Public Review Draft  
November 2007

Proposed Revisions for  
ASME A17.1a-200x ADDENDA  
To  
ASME A17.1-2007, Safety Code for Elevators and Escalators

TN 02-04

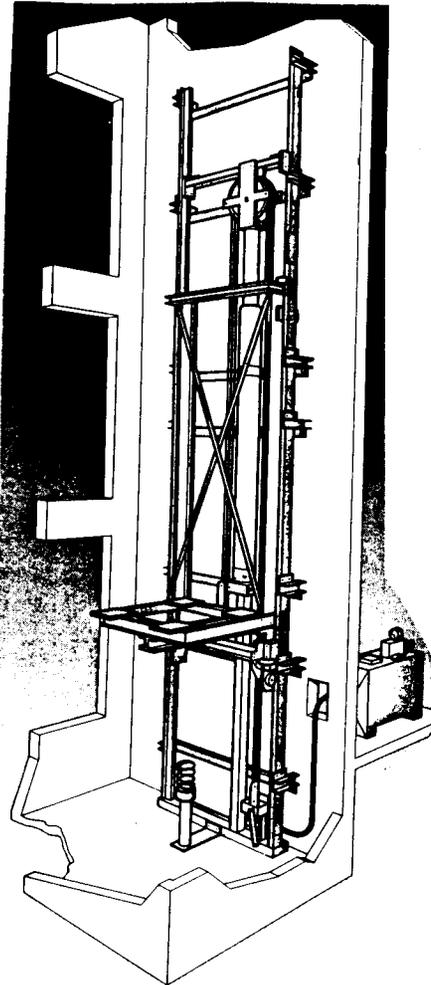
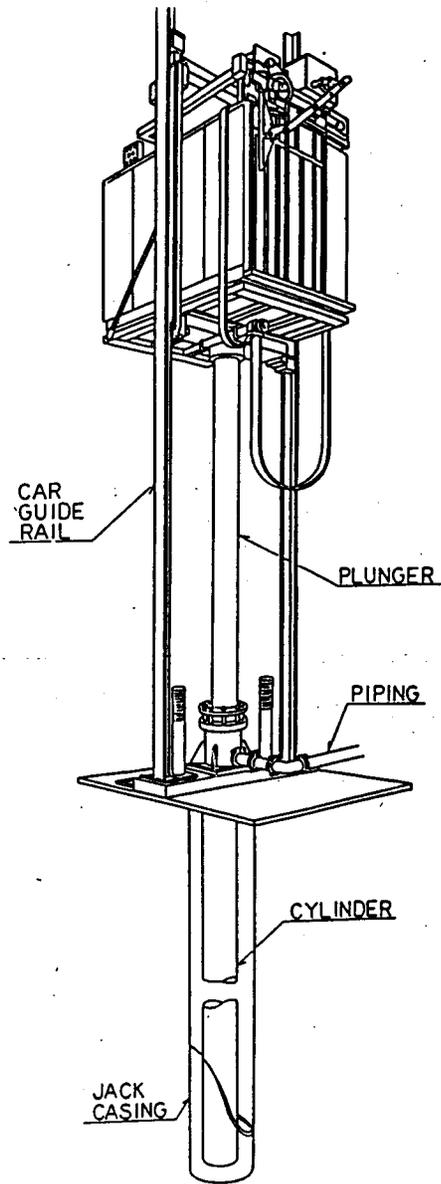
*Rationale: Added proper references for roped hydraulic elevators. Also see rationale for 8.4.11.14.*

Figure 8.4.11

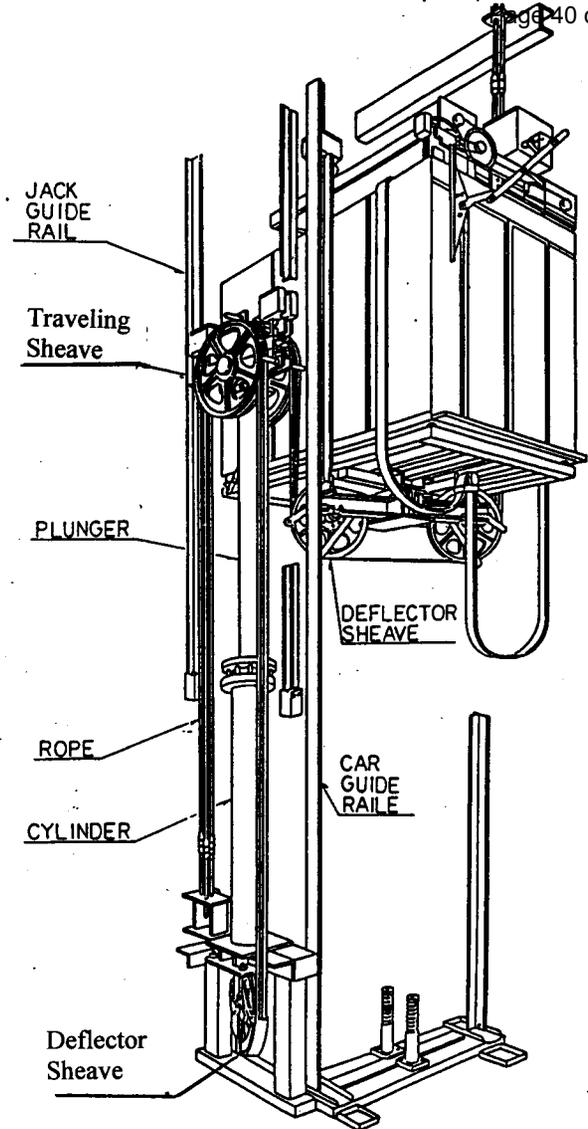
**8.4.11.2.1 Beams and Supports.** Overhead beams for attaching hitch plates (See Figure 8.4.11, Configuration (2)) shall be anchored to prevent overturning and displacement as a result of a horizontal seismic force. The seismic force shall be of not less than that required to produce an acceleration of:

*Proposed 8.4.11.3 is added for roped hydraulic elevators. Additional requirements for snag points were not included. Due to the lower heights and speeds of the hydraulic elevators, in comparison to its traction counterpart, it is expected much smaller clearances could be accommodated before any guarding would be necessary.*

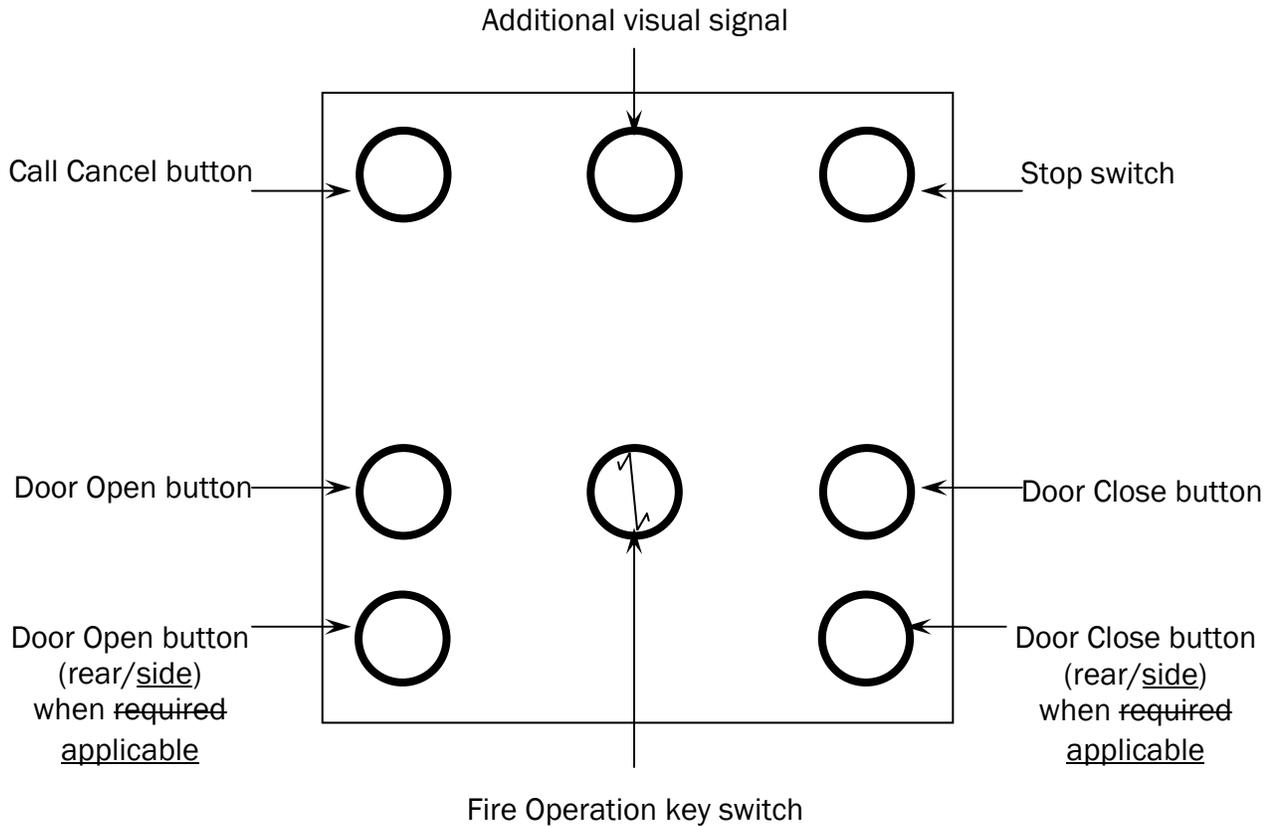
Add the word 'side' in the text indicating the lower left and lower right device positions

Editorial change to the word 'button' in all of these requirements - add (s) to every instance of the word button

**2.27.8 Switch Keys**

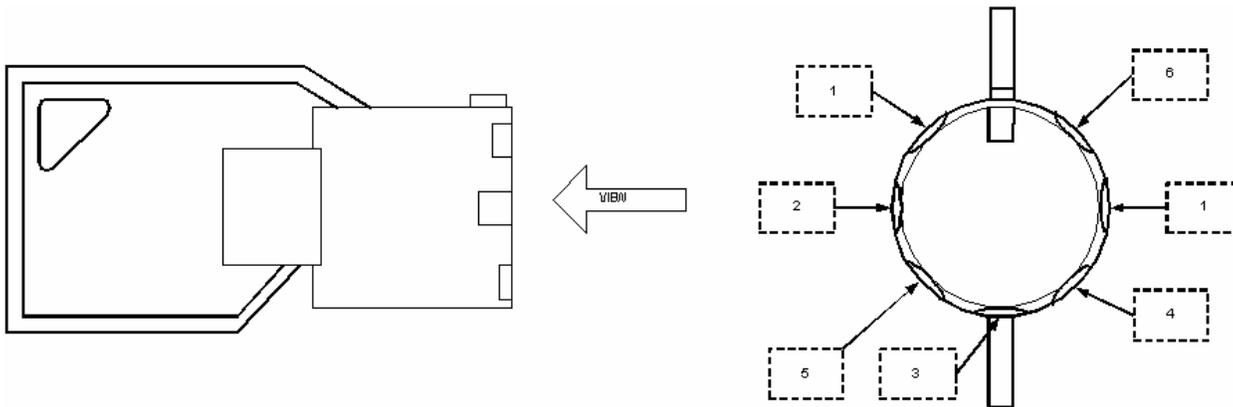
*Proposed Revision to A17.1, Requirement 2.27.8 as follows:*

The key switches required by 2.27.2 through 2.27.5 for all elevators in a building shall be operable by the same key. The keys shall be Group 3 Security (see 8.1). There shall be a key for each switch provided. These keys shall be kept on the premises in a location readily accessible to firefighters and emergency personnel, but not where they are available to the public. This key shall be of a tubular, 7 pin, style 137 construction and shall have a biting code of 6143521 starting at the tab sequenced clockwise as viewed from the barrel end of the key. The key shall be coded "FEO-K1". The possession of the "FEO-K1" key shall be limited to elevator personnel, emergency personnel and elevator equipment manufacturers.

Where provided, a lock box, including its lock and other components, shall conform to the requirements of UL 1037 (see Part 9).
